Photo 9

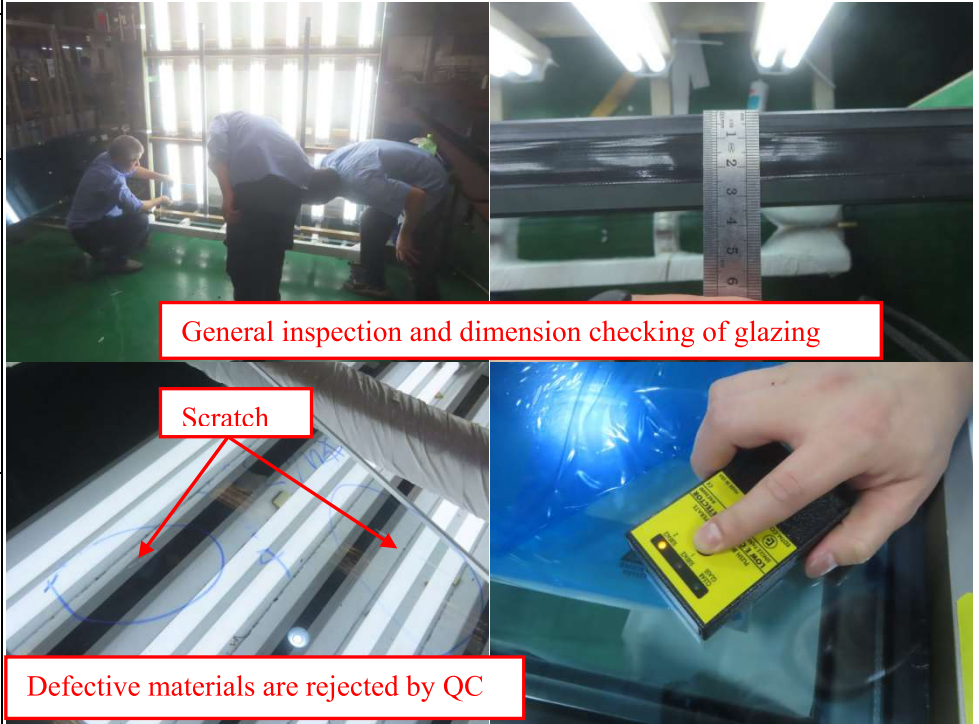
Scratch

Defective materials are rejected by QC

Photo 10

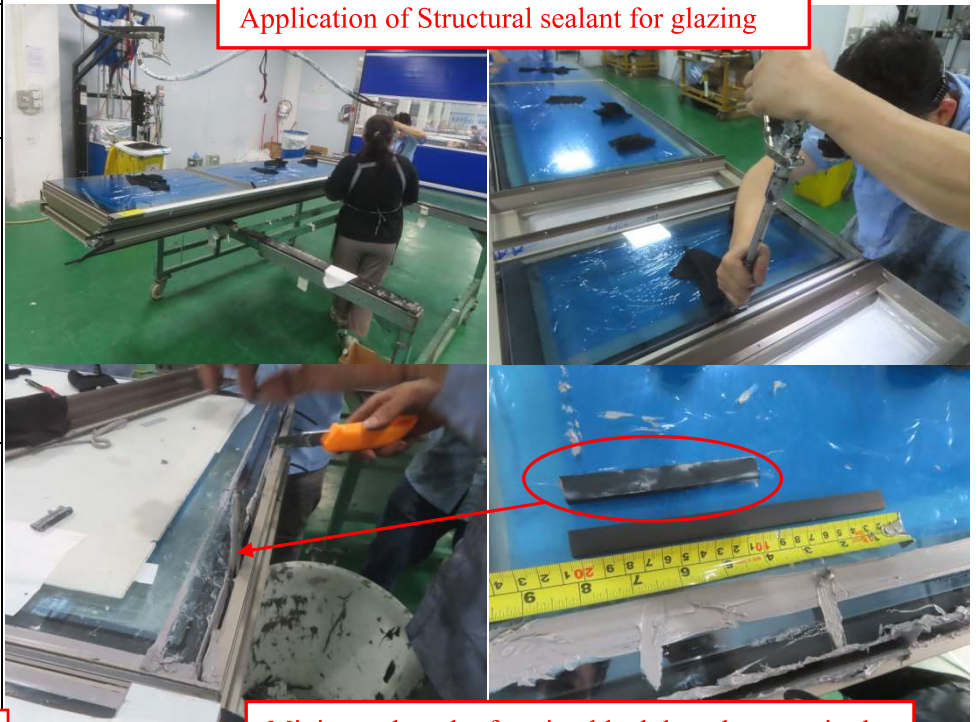
Minimum length of setting block less than required

#1:
黑膠墊最少要長 200mm, 補相

Setting block only 100mm less than required

Action:
- MIDI is reminded to carry out the remedial works prior products delivery and to improve workmanship for future works

Photo 11

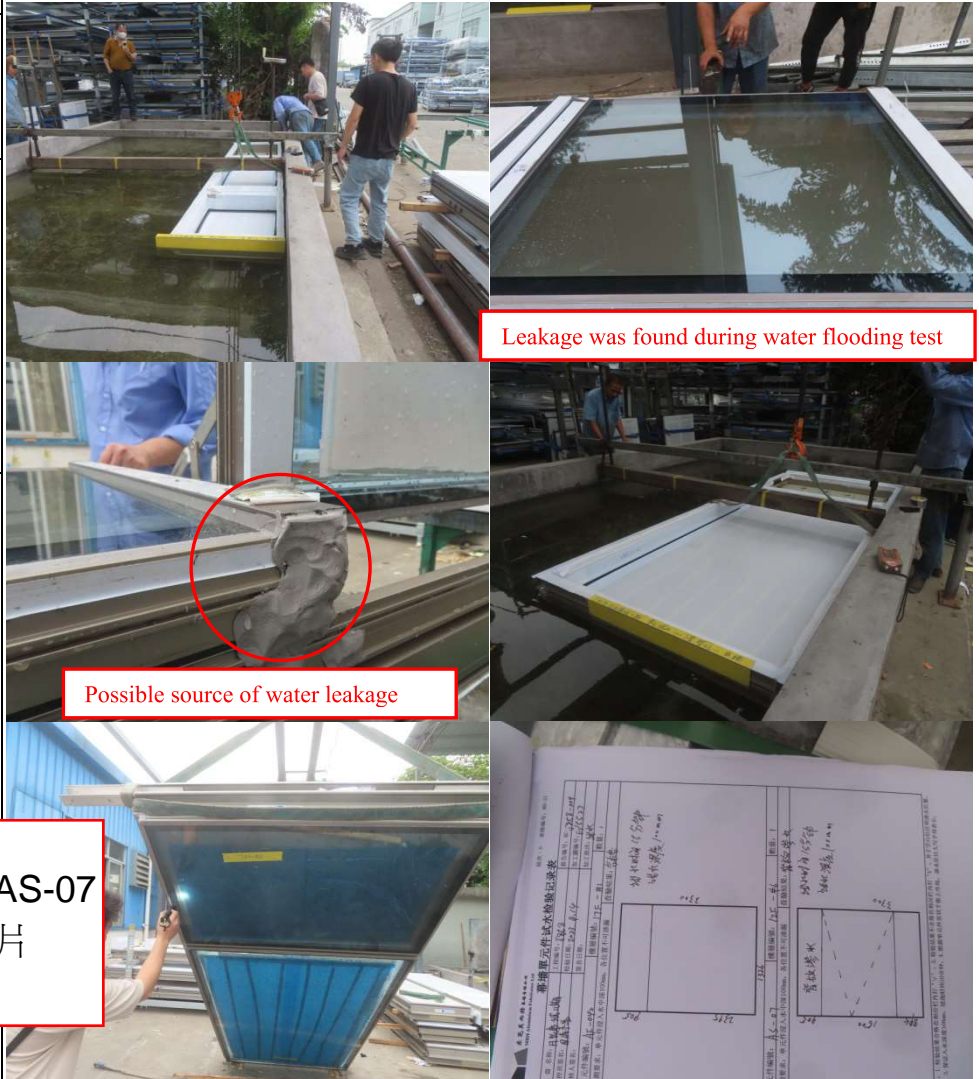
Description:
Water test of 2 numbers unitized panel.
Water leakage was found during flooding test for panel number 12/F_T3B-CW4_AS-07

Leakage was found during water flooding test

Possible source of water leakage

#2:
單元件12/F_T3B-CW4_AS-07
入水, 影合格試水紀錄照片

Action:
- MIDI is required to carry out their internal QA/QC method to improve workmanship for future works

Photo 13

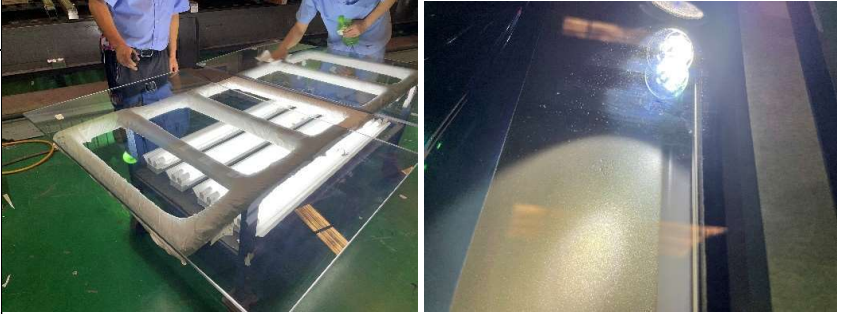
Missing wooden block for protection of gasket

#3: 對膠條保護再做好一點，飛機帶跟木壓到膠條的位置做點保護，影相。

Action:
- MIDI is reminded to
carry out the remedial
works prior products
delivery and to improve
workmanship for future
works
